UNITED STATES PATENT AND TRADEMARK OFFICE

APPLICATION NO.	FILING DATE	FIRST NAMED INVENTOR	ATTORNEY DOCKET NO.	CONFIRMATION NO.
09/463,549	01/27/2000	DANIEL HENRY DENSHAM	GJE-35	6468

Office Action Summary

DETAILED ACTION

Fig. 2a

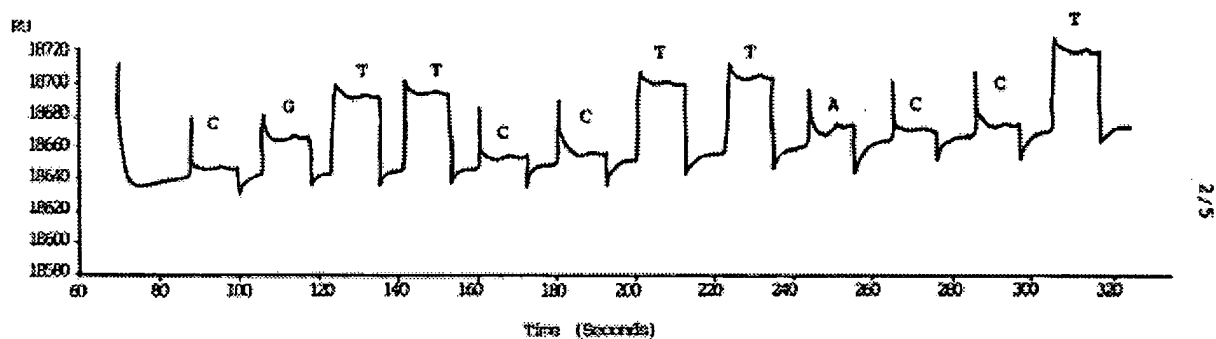
17. Of the examples provided, that found at page 14, bridging to page 15 of the disclosure is most relevant to the claimed method. As set forth therein the results obtained are presented in Figure 2. For convenience, Fig. 2a is reproduced below.

18. It is evident from the disclosure, including Fig. 2a, that the but a single template was being sequenced, an then the nucleotide sequence was determined at a rate of about 1 nucleotide per 20 seconds. Significantly, but a single nucleotide was incorporated into the complementary strand at a time, and that further nucleotide addition was proscribed due to the presence of a blocking group in the 3' position.

19. The specification does not set forth a reproducible procedure whereby dual blocking groups are present and are selectively removed.
